**PLANNING APPROVAL,
PLANNED UNIT DEVELOPMENT &
SUBDIVISION STAFF REPORT**

Date: June 6, 2013

<u>NAME</u>	Carmelite Nuns Discalced
<u>SUBDIVISION NAME</u>	Carmelite Nuns Discalced Subdivision
<u>LOCATION</u>	716 Dauphin Island Parkway (Northwest corner of Dauphin Island Parkway and Halls Mill Road, extending to the Southeast corner of Gosson Street and Johnston Avenue)
<u>CITY COUNCIL DISTRICT</u>	District 2
<u>PRESENT ZONING</u>	R-1, Single-Family Residential District, R-3, Multi-Family Residential District, and B-3, Community Business District.
<u>AREA OF PROPERTY</u>	1 Lot / 6.0± Acres
<u>CONTEMPLATED USE</u>	Planning Approval to allow a building expansion and expanded parking lot at an existing monastery in an R-3, Multi-Family Residential District, Planned Unit Development approval to allow multiple buildings on a single building site, and Subdivision approval to create one legal lot of record.
<u>TIME SCHEDULE FOR DEVELOPMENT</u>	Immediate.

SITE PLAN

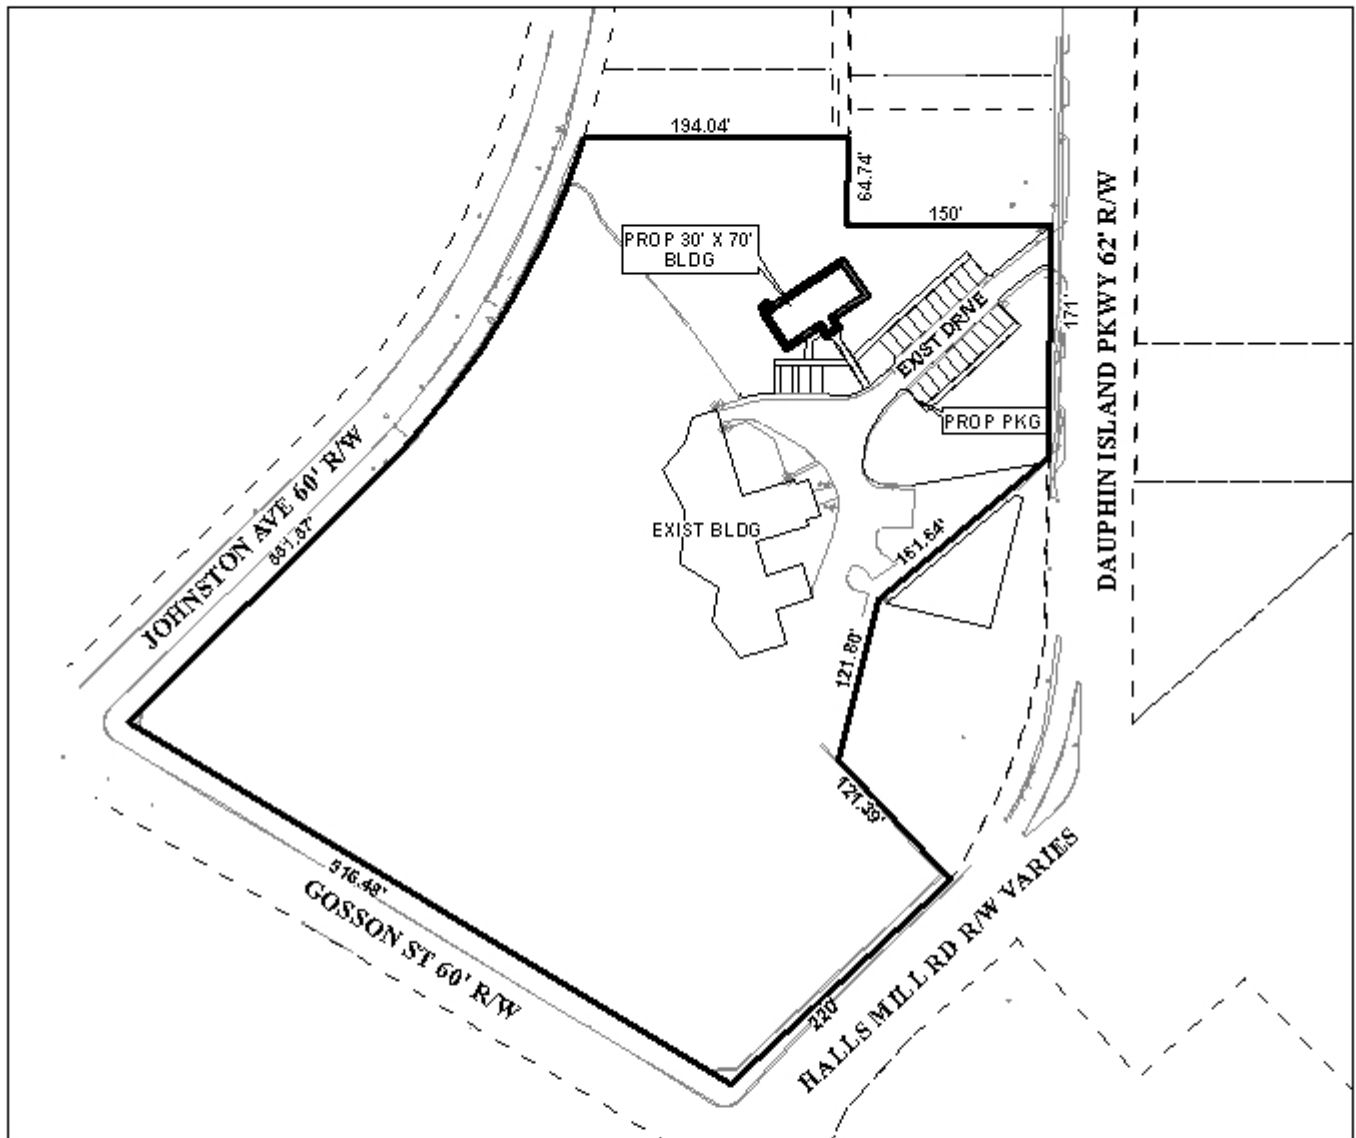
Driveway number, size, location and design to be approved by Traffic Engineering and conform to AASHTO standards. Standards for 90 degree parking include a 24 foot aisle. Changes should be made to the parking as shown (angled spaces or wider aisle) to meet parking standards.

Property to be developed in compliance with state and local laws that pertain to tree preservation and protection on both city and private properties (State Act 61-929 and City Code Chapters 57 and 64). Preservation status is to be given to the 72" Live Oak Tree located within the proposed Handicapped Parking. Any work on or under this tree is to be permitted and coordinated with Urban Forestry; removal to be permitted only in the case of disease or impending danger. Granting Preservation Status will require the relocation of proposed Handicapped Parking.

The entrance drive and drive aisle width in the parking area is indicated to be 20'. As Traffic Engineering has expressed in its comments, the standards for 90 degree parking include a 24 foot aisle. Changes should be made to the parking as shown (angled spaces or wider aisle) to meet parking standards. The entrance drive should be widened to 24' and the curb cut to Dauphin Island Parkway modified to meet Traffic Engineering requirements. If driveway gates are to be provided, such should be indicated and shown to meet the requirement for a three-vehicle, 60' queuing space out of the public right-of-way. The required widening of the drive will require a re-positioning and/or re-configuration of the proposed parking areas. The site plan does not indicate bumper stops or curbing around the parking areas; therefore it should be revised to indicate either one or the other. Urban Forestry has determined that Preservation status be given to the 72" Live Oak tree located within the proposed handicapped parking area. Any work on or under this tree is to be permitted and coordinated with Urban Forestry; removal to be permitted only in the case of disease or impending danger. This will require the relocation of that parking area.

An existing nose-in/back-out parking area along Dauphin Island Parkway is shown to be landscaped on the site plan, but no mention is made that the parking area is to be removed and landscaped. If that is the intent, the site plan should be revised to so indicate such is proposed.

The 25' minimum building setback line should also be shown on both site plans. The site plan does not indicate any over-story trees within the first 25' of either the Dauphin Island Parkway or Johnston Avenue frontages. As the site has an abundance of over-story trees located within the project area, the applicant should coordinate with Urban Forestry on what would be required within the frontage areas.

No public sidewalk is indicated along Johnston Avenue at the Northwest corner of the project area; therefore, a compliant City-standard sidewalk should be indicated in that area or a Sidewalk Waiver application submitted. No buffering is indicated along adjacent residential sites to the North; therefore, the site plan should be revised to provide such.

No dumpster is indicated on the site plan, nor is a note on the site plan indicating that no dumpster will be utilized. Therefore, the site plan should be revised to either indicate a compliant dumpster with screening and sanitary sewer drainage connection or a note should be placed on the site plan indicating that there will be no dumpster utilized and also indicating what type of garbage collection will be utilized.

- 1) revision of the site plan to indicate a 24' wide drive aisle;
- 2) revision of the site plan to indicate a compliant curb cut to Dauphin Island Parkway, to be coordinated with Traffic Engineering;

- 3) if driveway gates are proposed, revision of the site plan to indicate a three-vehicle, 60' queuing space out of the public right-of-way;
- 4) indication of bumper stops or curbing within the parking areas;

- 5) placement of a note on the site plan stating that the 72" Live Oak tree (within the proposed handicapped parking area) is granted Preservation status and any work on or under this tree is to be permitted and coordinated with Urban Forestry; removal to be permitted only in the case of disease or impending danger;

- 6) revision of the site plan to locate the proposed handicapped parking area away from the 72" Live Oak tree given Preservation status;
- 7) revision of the site plan to indicate that the nose-in/back-out parking along Dauphin Island Parkway is to be removed and replaced with landscaping, if such is the case;

- 8) revision of the site plan to indicate the 25' minimum building setback line along all street frontages;
- 9) revision of the site plan to indicate required over-story trees within the first 25' of street frontages, to be coordinated with Urban Forestry due to the abundance of over-story trees within the project area;

- 10) revision of the site plan to indicate a City-standard public sidewalk along Johnston Avenue at the Northwest corner of the project area, or the submission of a Sidewalk Waiver application;

- 11) revision of the site plan to indicate a buffer along adjacent residential sites to the North of the project area;
- 12) revision of the site plan to indicate a compliant dumpster with enclosure and sanitary sewer drainage connection, or the placement of a note on the site plan stating that no dumpster will be utilized and stating what method of garbage collection will be utilized; and
